A MENDED IN RED
1 0 JUL 2012
By: Matt Teo (name)
of the ULDA

PLANS AND DOCUMENTS
referred to in the ULDA
APPROVAL dated 13 / 7 / 12

PROJECT:
Village National Blackwater

DRAWING:
Site Plan

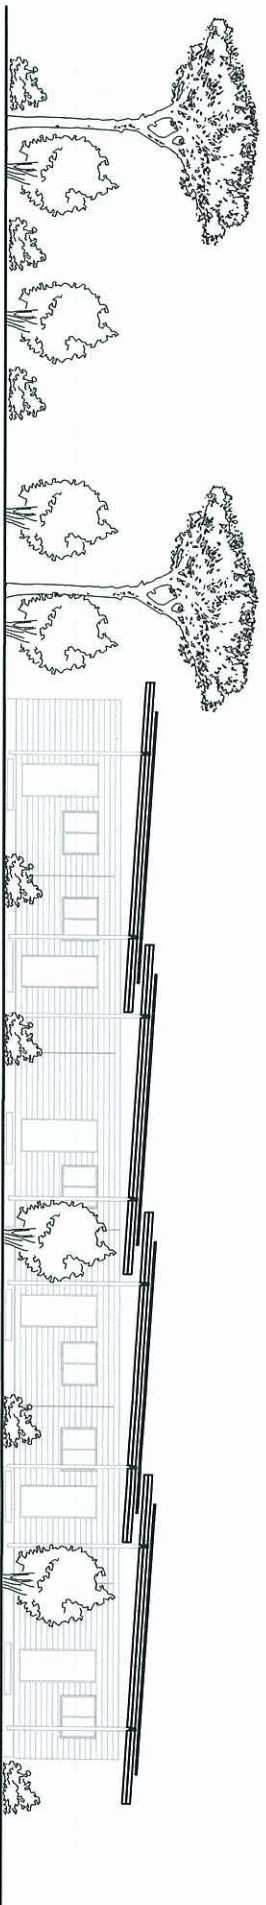
AMENDED IN RED
10 JUL 2012
By: Malcolm (name)
of the ULDA
